Sydney Football Stadium

Stage 2 Development Application (SSD9835)
Design Integrity Assessment Report

Date: May 2019
Author: Infrastructure NSW
Revision: 1

Figure 1: Competition winning landscape concept

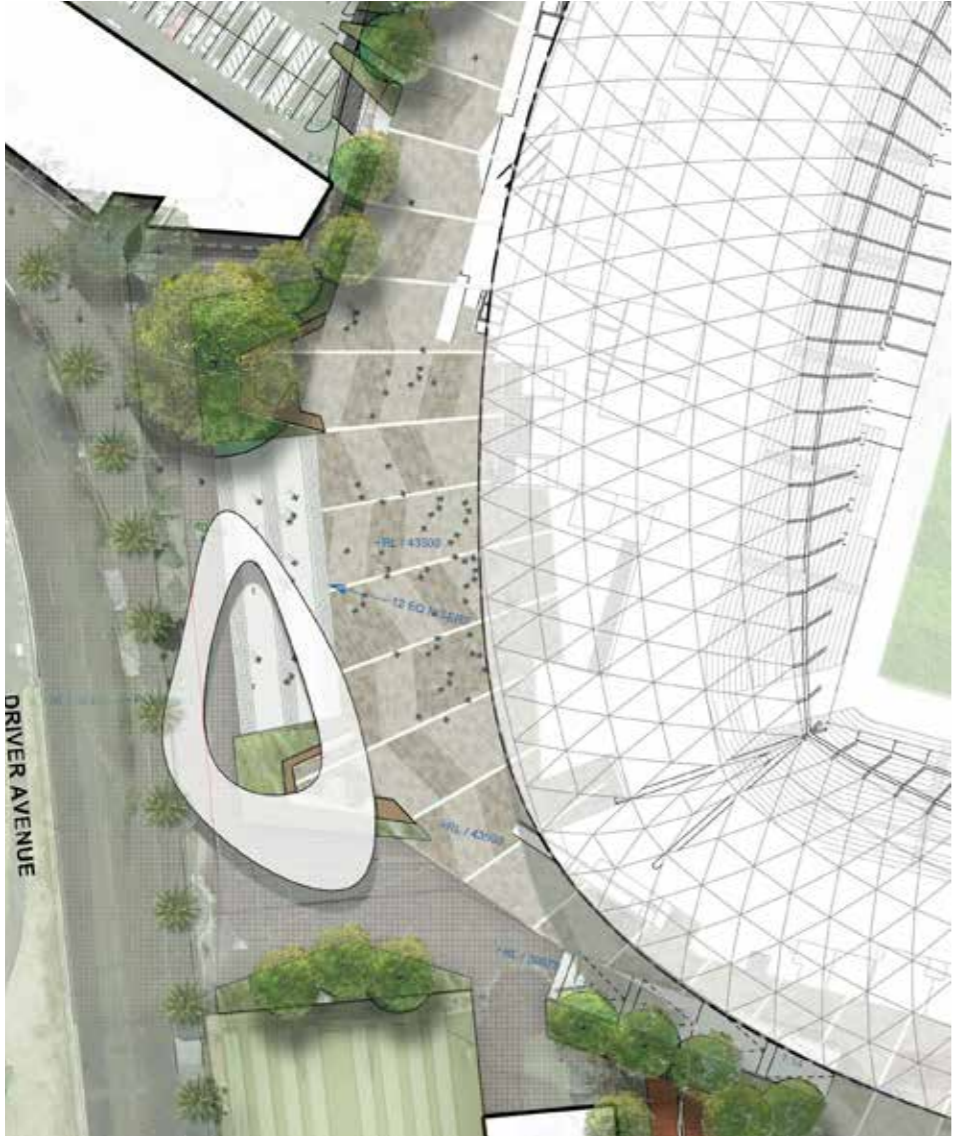
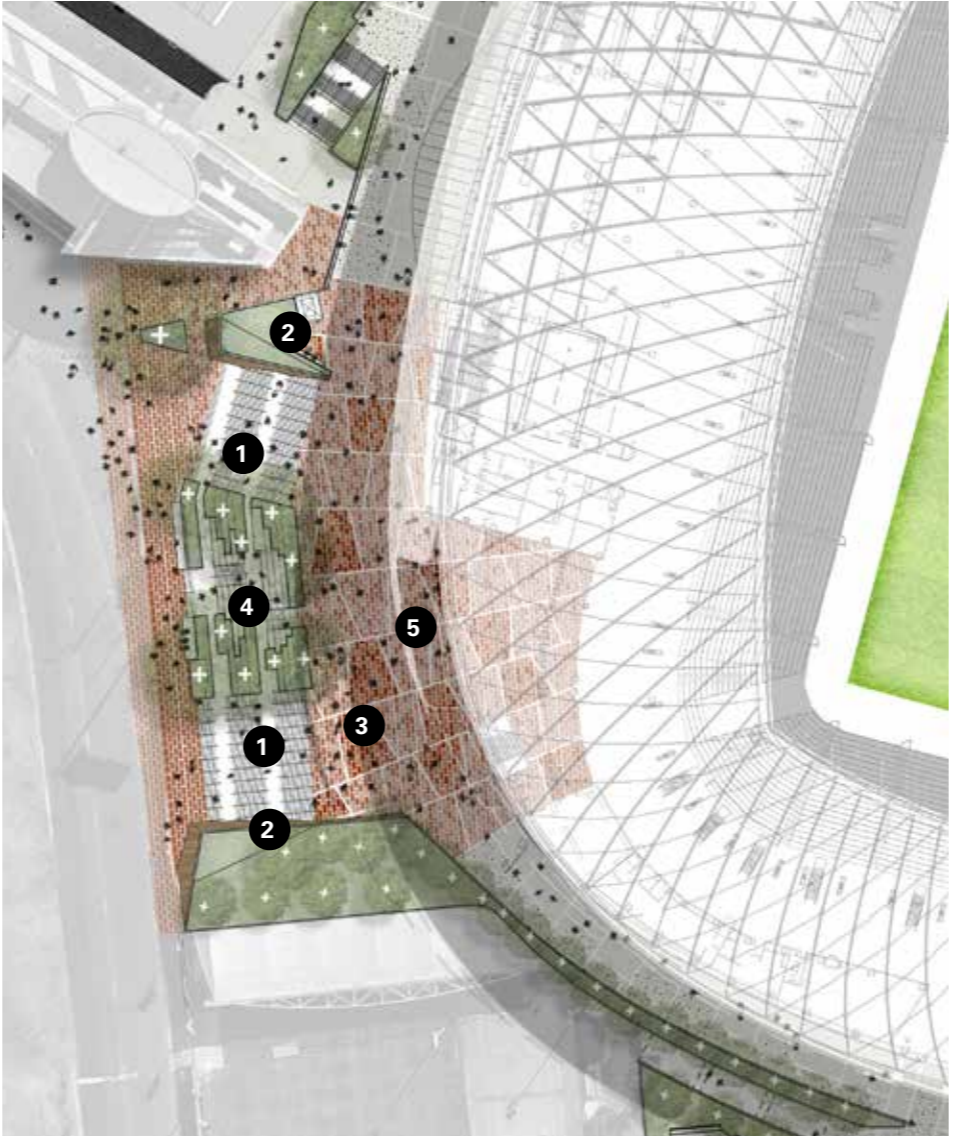
Driver Avenue Steps		
Competition Concept Design	Proposed Design	Design Changes
		<ol style="list-style-type: none"> 1. Split Movement Paths in to 2 streams <ul style="list-style-type: none"> - Stairs have been orientated to respond to desire lines - 3 flights of stairs respond better to human scale 2. Folding Brick stair abutments <ul style="list-style-type: none"> - Create a site Gateway which references the language of gateways in the precinct. - Responds to Driver Avenue materiality - Planting at upper level will cascade down walls 3. Removal of the Oculus <ul style="list-style-type: none"> - Removal accommodates additional public realm and an entrance arrival more appropriate to the parkland setting 4. Establish central landscaped area with seating terraces <ul style="list-style-type: none"> - Provides for amenity, views over Moore Park and Kippax Lake - Forms a secondary movement path 5. Detailed paving to mark site & stadium entry

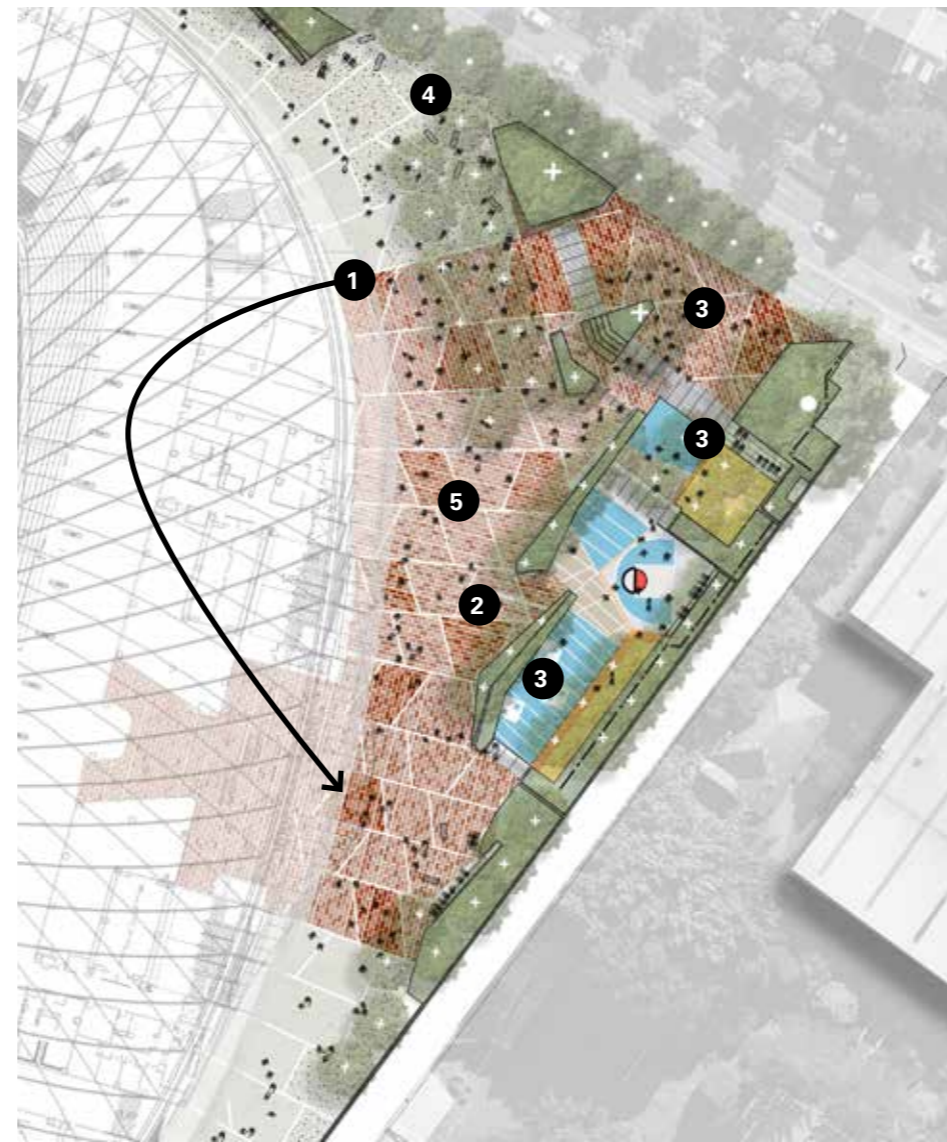
1. Stadium Entry moved from north east Corner to Paddington Lane
 - Activity zone restructured to direct pedestrians to stadium entry
 - Structured to allow high volumes of pedestrian egress
2. Removal of southern stairs on Paddington Lane resulting in 'ramped concourse'
 - 1:21 from Moore Park Road to stadium entry
 - 1:14 from Stadium Entry to SCG
3. Arrangement of community area
 - Steps are now on desire line from Moore Park Road
 - Creates stepped activity platforms following concourse grade with flush connections at landings
 - Removal of the full basketball court to be replaced with basketball hoops, exercise provision and informal recreation as a more diverse community offering
4. Maintain accessible connection from Moore Park Road
5. Detailed paving to mark site and stadium entry

Figure 3: Competition winning concept design

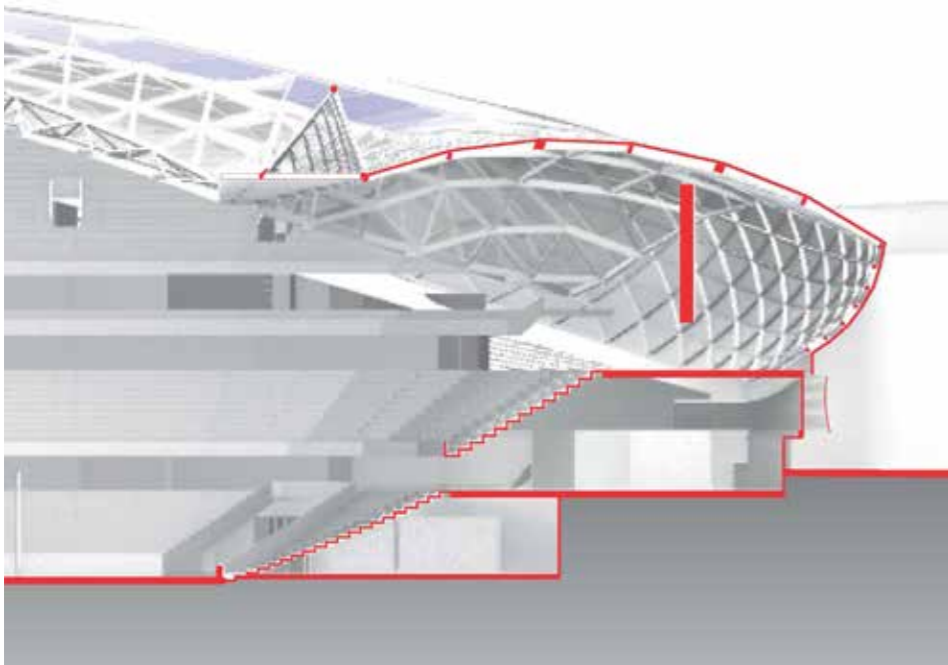
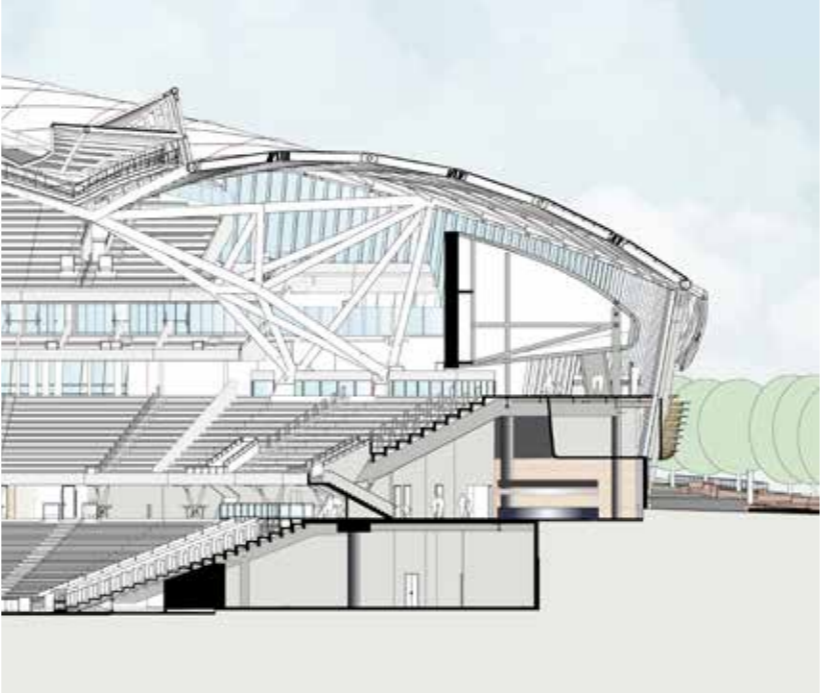
Solar Photovoltaic Array		
Competition Concept Design	Proposed Design	Design Changes
		<p>Distribution of the photovoltaic array modified to better integrate with roof design and provide for more efficient operation.</p>

Roof Line		
Competition Concept Design	Proposed Design	Design Changes
		<p>Roof height at northern and southern ends lowered approximately 1-2 metres to assist in reducing scale of the building.</p>

Extension to Stepped Terraces

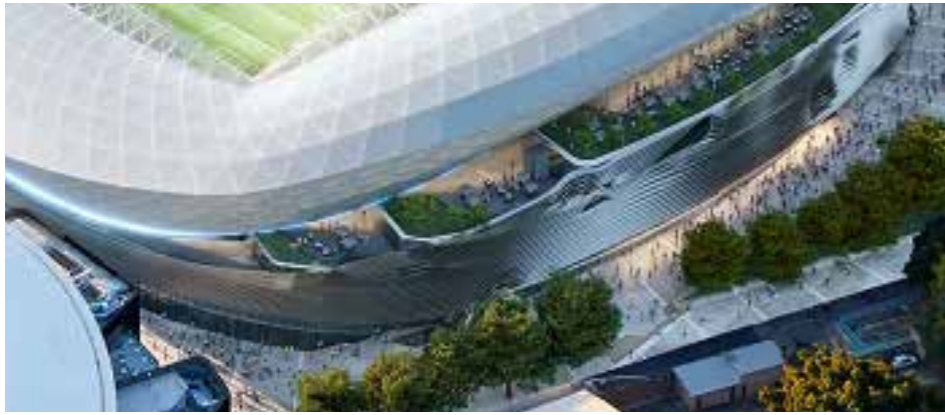
Minor extension to the landscaped terraces to the east and west on levels 3 and 4 to improve landscaping areas.

North Eastern Entry

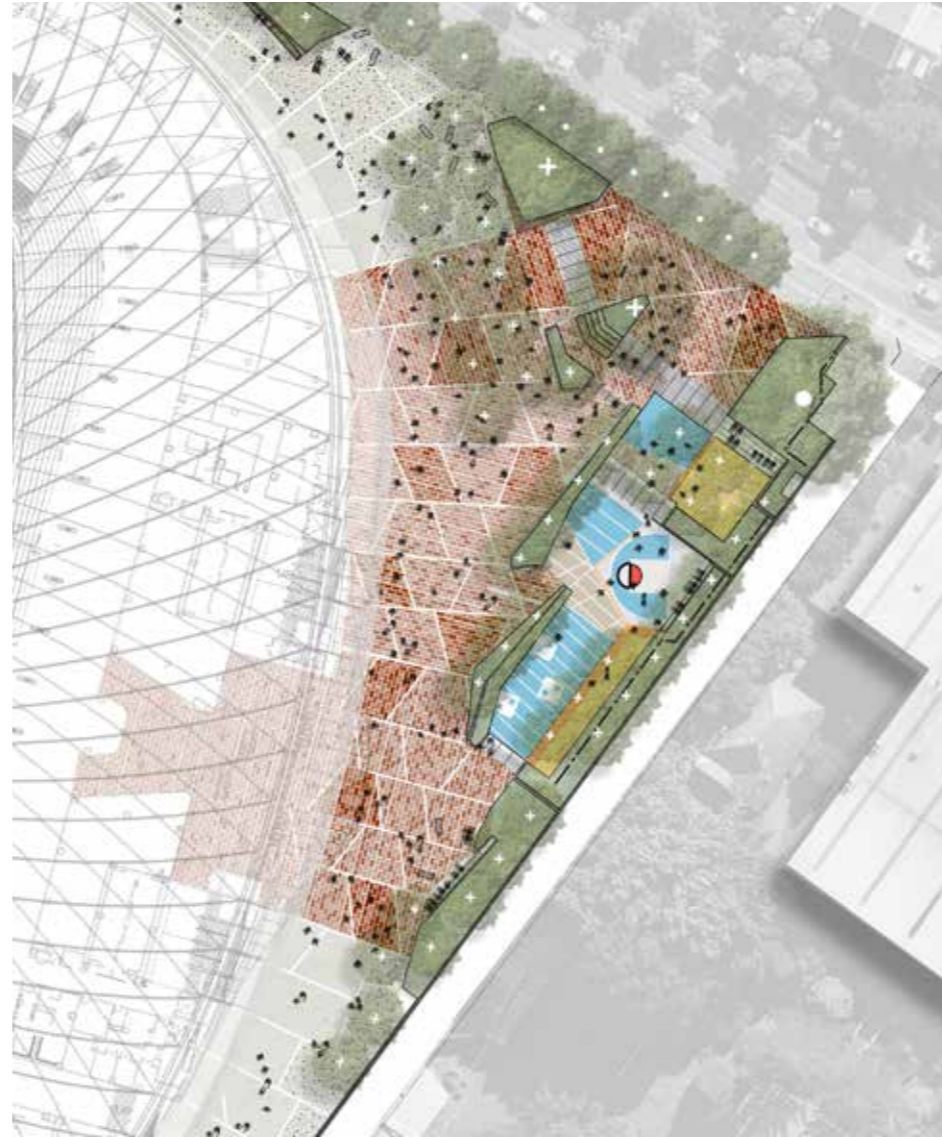
Amalgamation of the north east and south east entries to one entry on the eastern elevation.
